<Noise on COM pin>

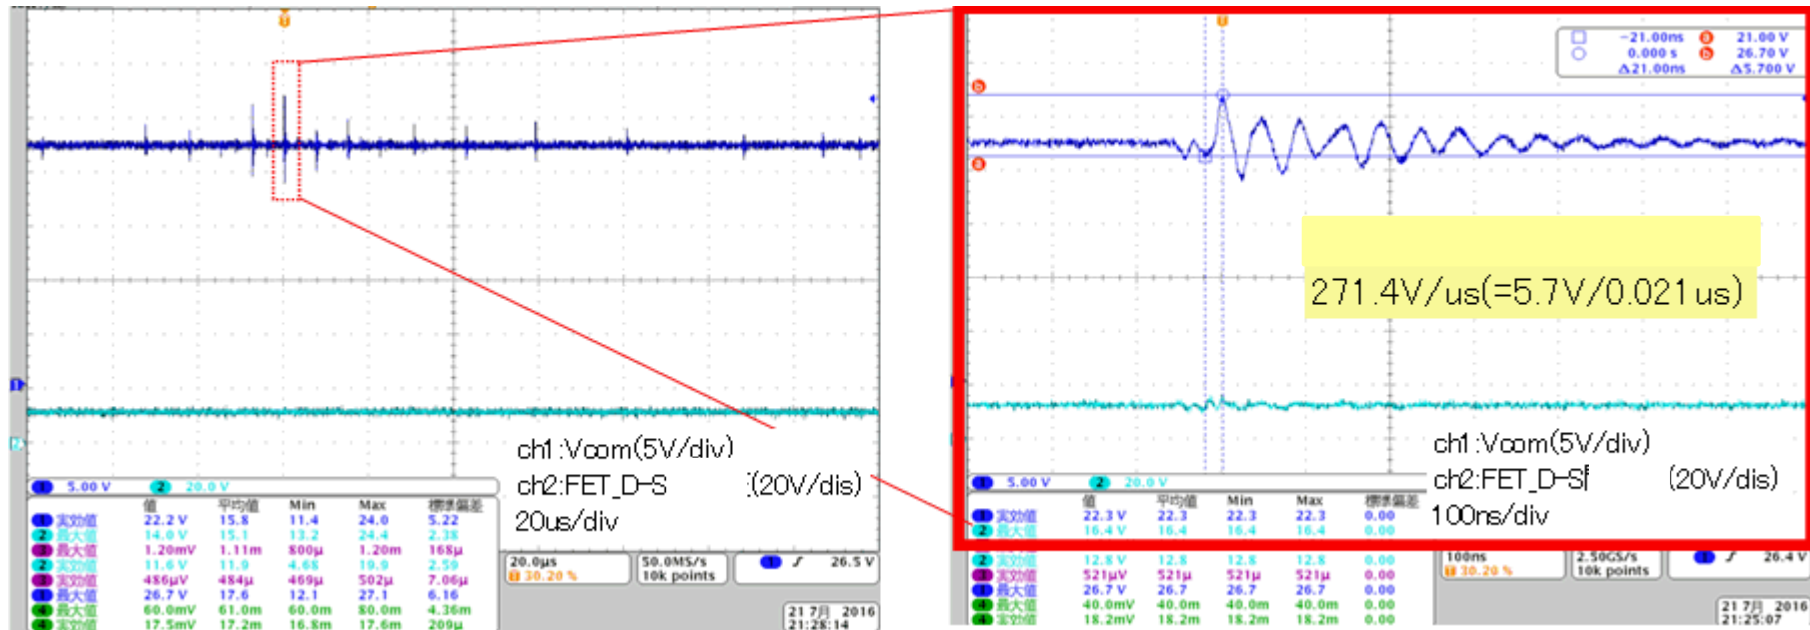
On above figure, if the noise which is over 0.5V/us gradient is added to COM pin, does the device cause damage to the internal gate driving circuitry?

- Voltage Gradient : 0.5V/us over
- The noise voltage difference : 5~6V
